ADDENDUM NO. 2

S10 GENERATOR, WELL PUMP, AND SITE IMPROVEMENTS

LACEY CONTRACT NO. PW 2022-29

Issued this 20th day of March 2024.

DRAWING: **G-7** OF: **11**

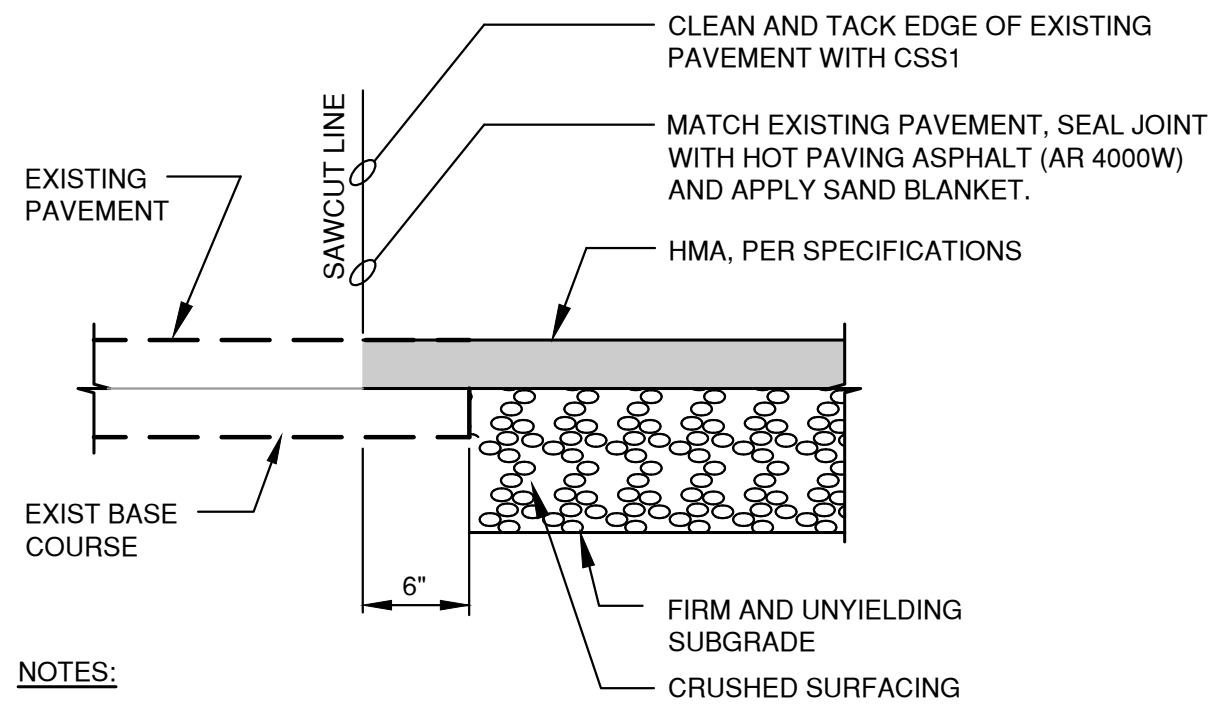
ITEM NO. 1: **Sheet G-7**

- 1) *The revisions include the addition of asphalt trench repair and details.*

DELETE Sheet G-7 in its entirety and **REPLACE** it with the new Sheet G-7 as attached.

- PATCH SHALL BE MACHINE ROLLED FLUSH WITH EXISTING PAVEMENT AND SHALL BE PLACED PER SECTION 5-04 OF THE WSDOT SPECIFICATIONS.
- ALL HMA SHALL BE PER SPECIFICATIONS.

- ALL JOINTS SHALL BE FULL DEPTH SAW CUT.
- ALL CATCH BASINS, VALVES AND OTHER APPURTENANCES SHALL BE TACK COATED WITH AN ASPHALT EMULSION PRIOR TO THE APPLICATION OF HMA.
- COMPACTED HMA SHALL NOT EXTEND MORE THAN 1/4" ABOVE THE EXISTING SURFACE.
